Project	IEEE 802.16 Broadband Wireless Access Working Group < http://ieee802.org/16 >
Title	Clarification of Repetition
Date Submitted	2005-07-18
Source(s)	Jaehye Cho, Seungjoo Maeng, Jaeho Jeon, jaehye1.cho@samsung.com Soonyoung Yoon, Jeong-Heon Kim, Jaehyok Lee, Myungkwang Byun, Inseok Hwang, Panyuh Joo, Jiho Jang, Sanghoon Sung, Hoon Huh, janghoon yang, ByoungHa Yi Samsung Electronics Co. Ltd.
Re:	IEEE P802.16-2004/Cor1-D3
Abstract	Clarification of repetition.
Purpose	Adoption of suggested changes into IEEE P802.16-2004/Cor1-D4
Notice	This document has been prepared to assist IEEE 802.16. It is offered as a basis for discussion and is not binding on the contributing individual(s) or organization(s). The material in this document is subject to change in form and content after further study. The contributor(s) reserve(s) the right to add, amend or withdraw material contained herein.
Release	The contributor grants a free, irrevocable license to the IEEE to incorporate material contained in this contribution, and any modifications thereof, in the creation of an IEEE Standards publication; to copyright in the IEEE's name any IEEE Standards publication even though it may include porti

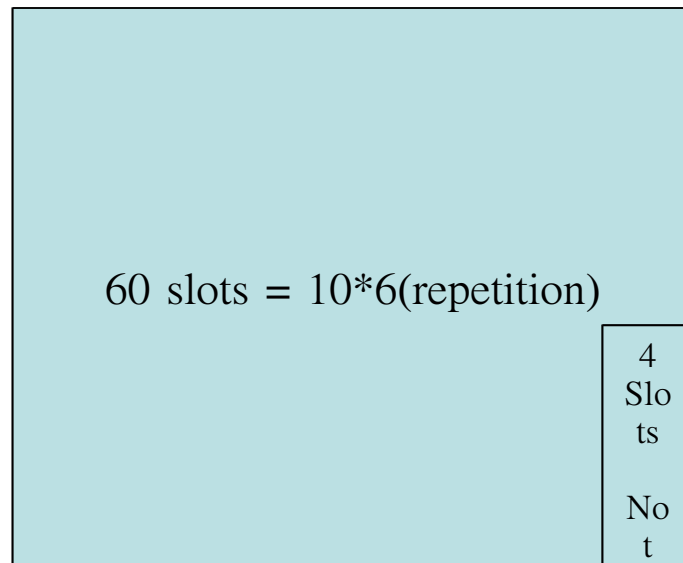
This inefficiency can be avoided by allowing to allocate the slots in the range from the whole multiples of repetition factor R to a whole multiple of the repetition factor R (let's say it K) to K + (R-1) for the downlink.

For example, when the required number of slots before the repetition is 10 and the repetition of R=6 shall be applied for the burst transmission, then the number of the allocated slots (Ns) for the burst can be 60 slots ~ 65 slots. (See the diagram below)

Repetition coding can be used to further increase signal margin over the modulation and FEC mechanisms. In the case of repetition coding, $R = 2, 4, \text{ or } 6$, the number of allocated slots (N_s) shall be a whole multiple of the repetition factor R for uplink. For downlink, the number of allocated slots (N_s) may only exceed $K \cdot R$ by at most $R-1$ slots, where K is the number of slots before repetition. For example, when the required number of slots before the repetition is 10 and the repetition of $R=6$ shall be applied for the burst transmission, then the number of the allocated slots (N_s) for the burst can be from 60 slots to 65 slots.
